Submission to Draft Macquarie-Castlereagh Regional Water Strategy

Department of Planning Environment – Water
regionalwater.strategies@dpie.nsw.gov.au

Thank you for the opportunity to respond to the latest draft of the Macquarie-Castlereagh Regional Water Strategy (MCRWS).

Figure 17

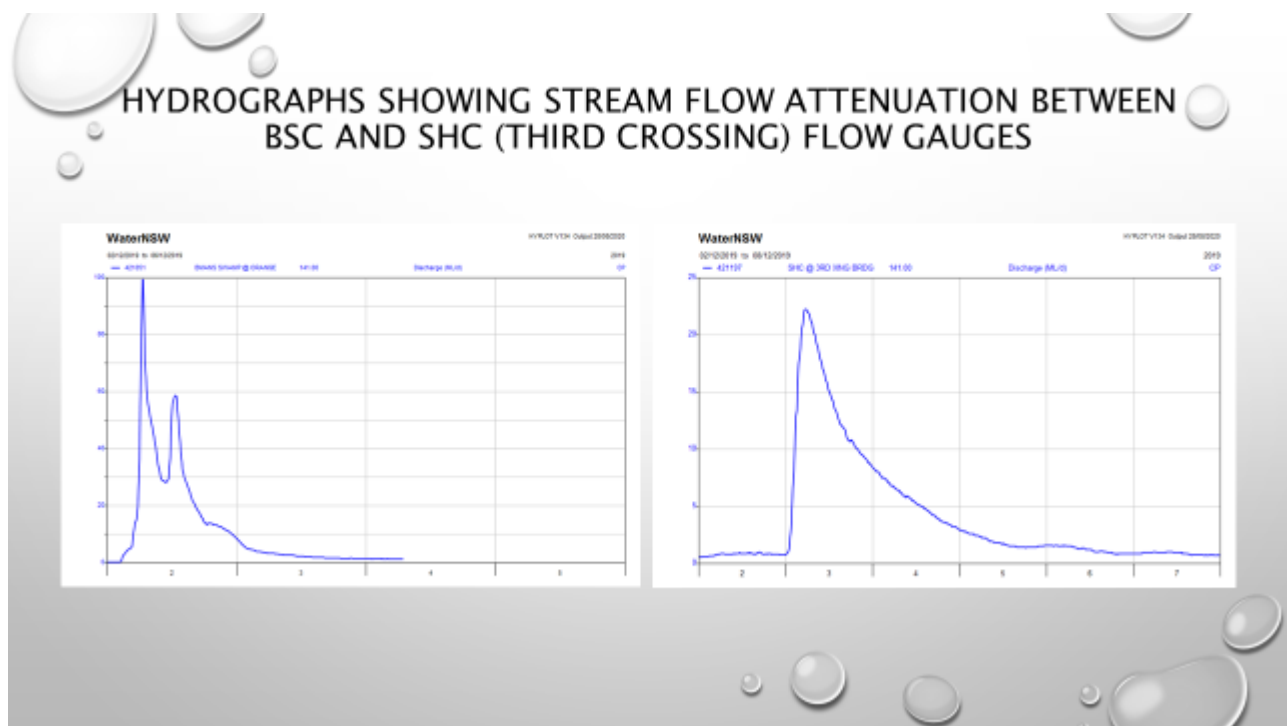
These Water NSW hydrographs demonstrate the stream flow attenuation between the two Water NSW stream flow gauges just a short distance downstream, and the impact that extracting flow upstream can have on the ability of flows to transport any distance downstream.

The hydrograph on the left shows a rainfall runoff event in BSC on 2 December 2019 under dry conditions.

Peak flow reached 99.323 ML/d and produced a runoff volume (after extracting 14.04 ML with Stage 1 stormwater harvesting) of 26.97 ML over 52.25 hours.

The hydrograph on the right shows the same runoff event measured downstream at the Third Crossing gauge in SHC on 3 December 2019.

The peak flow in SHC attenuated down from 99 ML/d to 22.257 ML/d over the 9 Km distance, resulting in a downstream runoff volume of 21.46 ML over 134.75 hours.

There was a hydrological loss of flow volume under dry conditions of 5.51 ML between the two hydrometric gauges for the runoff event.

Figure 18

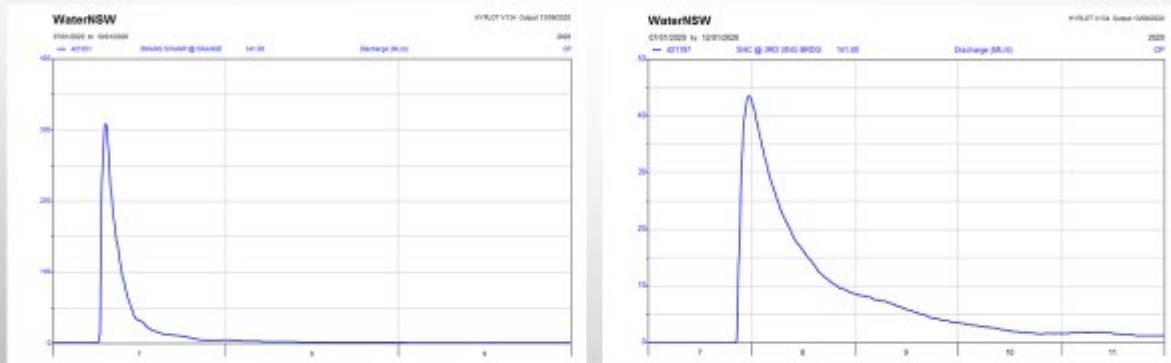
Similarly, the hydrograph on the left shows a rainfall runoff event in BSC on 7 January 2020.

Peak flow rate was 306.049 ML/d.

After harvesting 11.89 ML of stormwater runoff, the remaining downstream flow volume was 41.193 ML over 47.5 hours.

The hydrograph on the right shows the same runoff event measured downstream at the Third Crossing gauge in SHC on 7 January 2020.

Peak flow rate attenuated down from 306 ML/d to 42.324 ML/d.

Total runoff volume measured downstream at the Third Crossing was 31.089 ML over 92.5 hours.

There was a hydrological loss of flow volume, again under dry conditions, of 10.104 ML between the two hydrometric gauges for this runoff event.

Figure 19

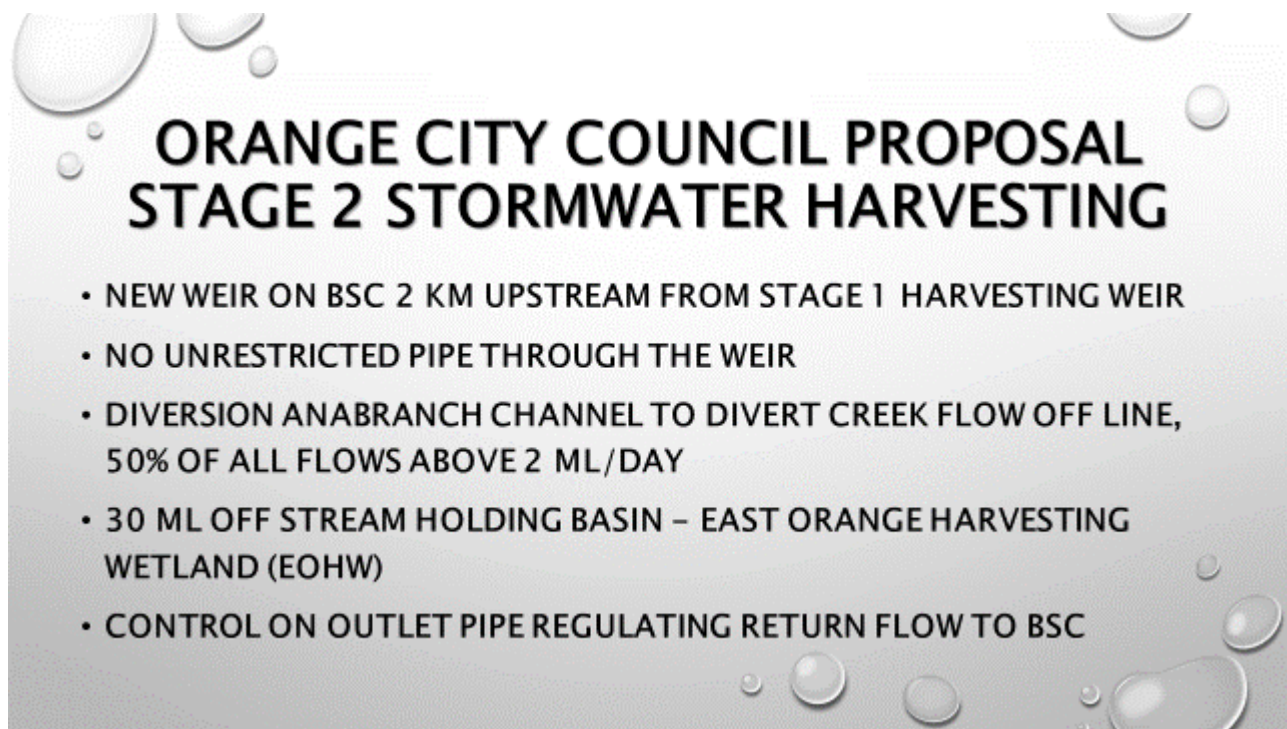
Which brings us to the new assault on the SHC water source by Orange City Council.

ORANGE CITY COUNCIL PROPOSAL STAGE 2 STORMWATER HARVESTING

- NEW WEIR ON BSC 2 KM UPSTREAM FROM STAGE 1 HARVESTING WEIR
- NO UNRESTRICTED PIPE THROUGH THE WEIR
- DIVERSION AN A BRANCH CHANNEL TO DIVERT CREEK FLOW OFF LINE, 50% OF ALL FLOWS ABOVE 2 ML/DAY
- 30 ML OFF STREAM HOLDING BASIN – EAST ORANGE HARVESTING WETLAND (EOHW)
- CONTROL ON OUTLET PIPE REGULATING RETURN FLOW TO BSC

Figure 20

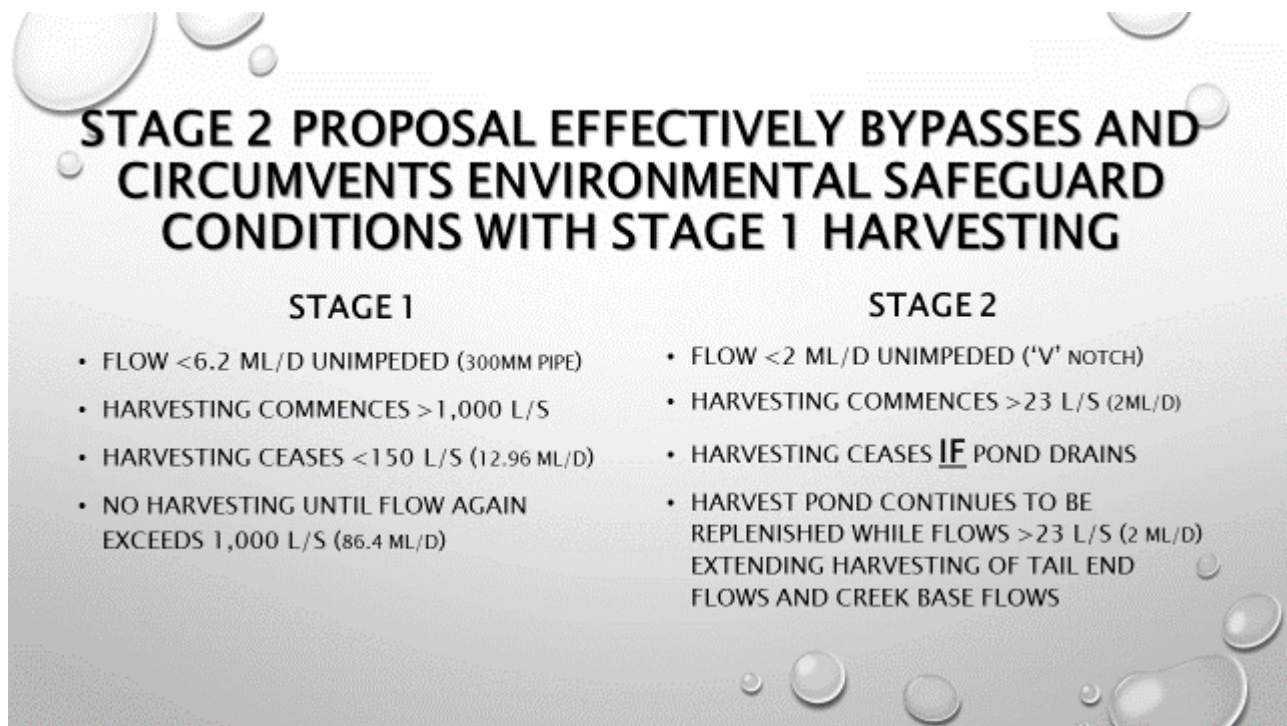
The new stormwater harvesting scheme being proposed consists of the elements as above.

STAGE 2 PROPOSAL EFFECTIVELY BYPASSES AND CIRCUMVENTS ENVIRONMENTAL SAFEGUARD CONDITIONS WITH STAGE 1 HARVESTING

Figure 22

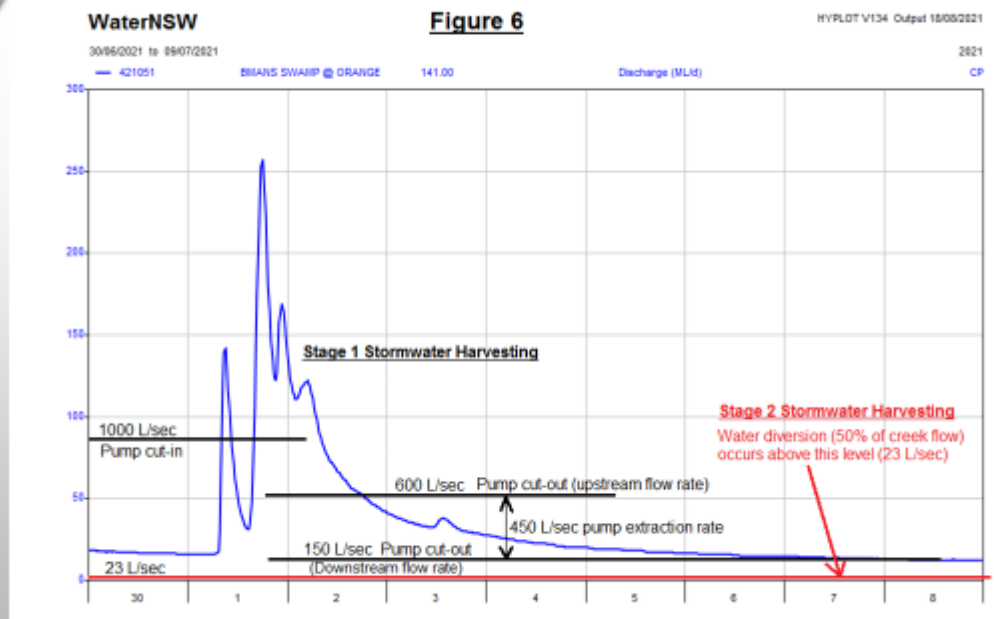
50% of all flows above 23 L/sec or 2 ML/day, will be diverted into the off creek wetland holding basin.

Draining of the wetland holding basin when full takes 33.3 hours (1.4 days) @ 250 L/sec. Meanwhile, the volume being drained from the holding basin will be replenished by all flows above 23 L/sec.

The difference between the Stage 1 and Stage 2 stormwater harvesting scheme's operating regimes is demonstrated on a hydrograph for a runoff event.
